STAFF REPORT
COMMUNITY DEVELOPMENT DEPARTMENT

HEARING DATE: June 3, 2021
 TO: Planning & Zoning Commission
 FROM: Joseph Dodson, Associate Planner
 208-884-5533
 SUBJECT: H-2010-0023
 Gramercy Commons CUP
 LOCATION: The site is located at 1873, 1925, and 2069 S. Wells Avenue, in the NW ¼ of the NE ¼ of Section 20, Township 3N., Range 1E.

Conditional Use Permit request for a multi-family development consisting of 164 age-restricted units within a multi-story building wrapped around a multi-story parking garage on 5.24 acres of land in the C-G zoning district, by Intermountain Pacific, LLC.

B. Landscape Plan (dated: 3/23/2021)

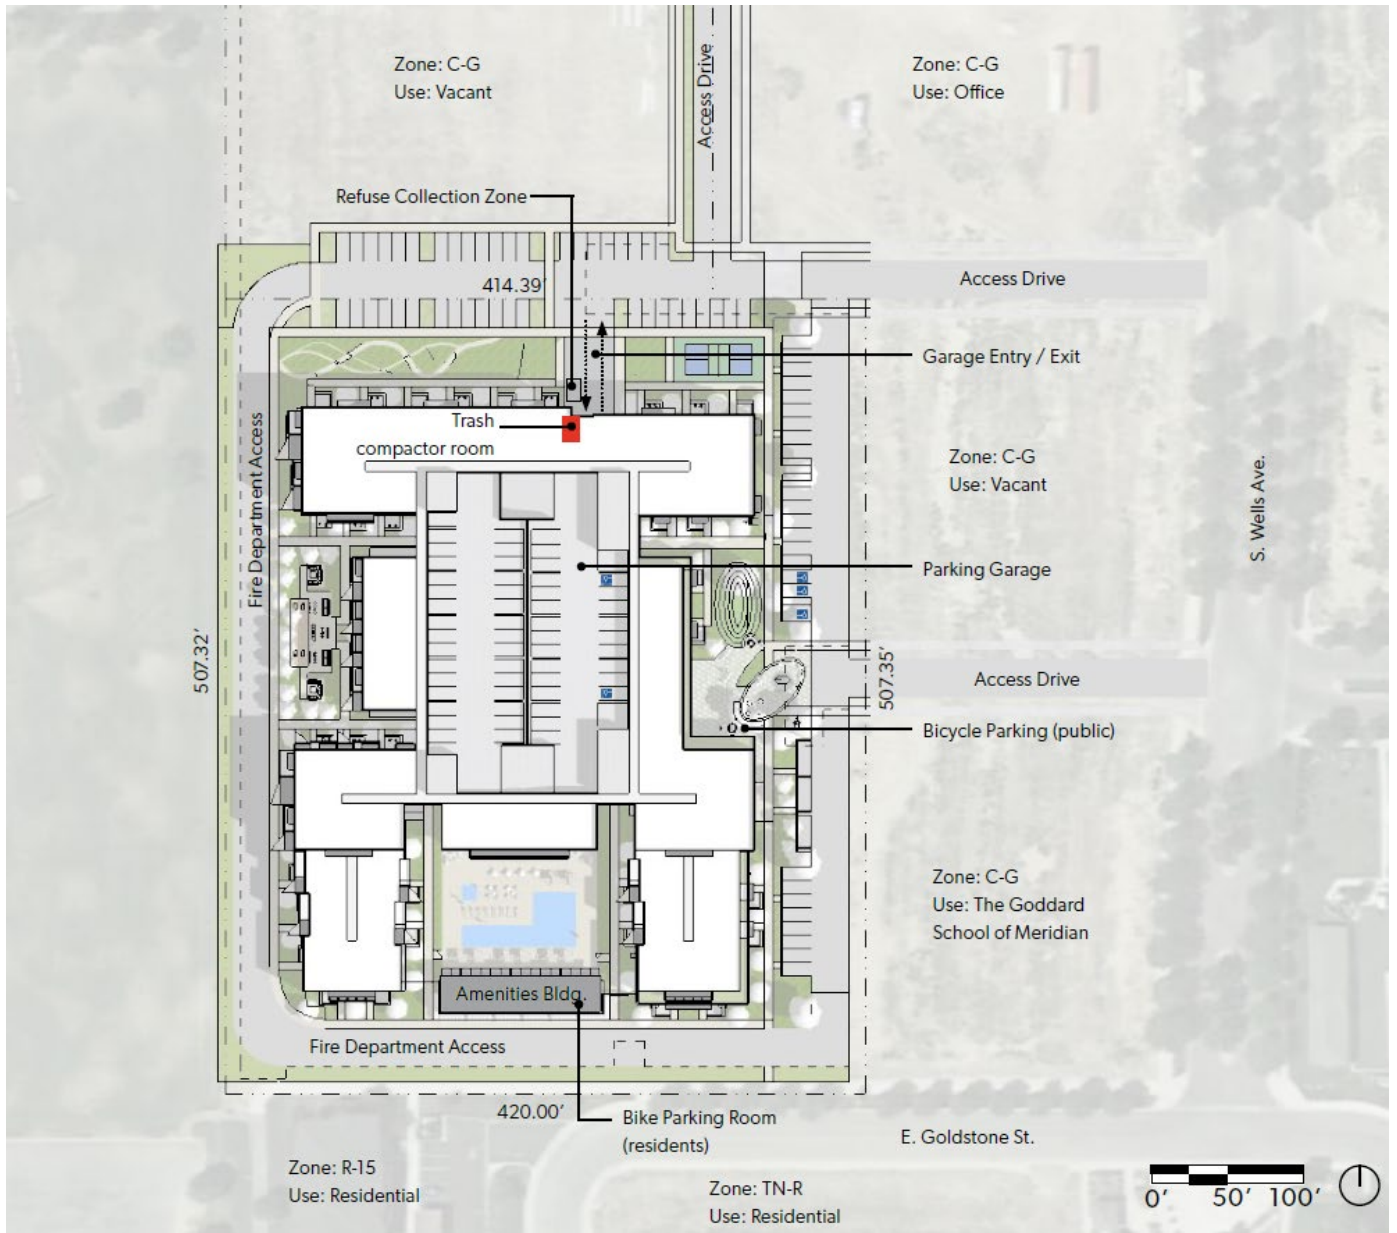
*The submitted landscape plan depicts an area of landscaping along the perimeter of the circumventing drive aisle except for along the east property boundary. It appears there is enough area for the required landscaping but it is not shown on the submitted plans. Furthermore, this landscape strip is also required to be vegetated with trees located no more than 35 linear feet apart throughout the buffer—trees may also be grouped together where necessary and visually appealing. **At the time of CZC submittal, the Applicant should correct the landscape plans to show compliance with both of these requirements.***

- a. Depict the required parking lot landscaping along the east boundary adjacent to the drive aisle and east property line;
 - b. Throughout all of the perimeter landscaping, depict the required vegetation and trees per UDC 11-3B-8.
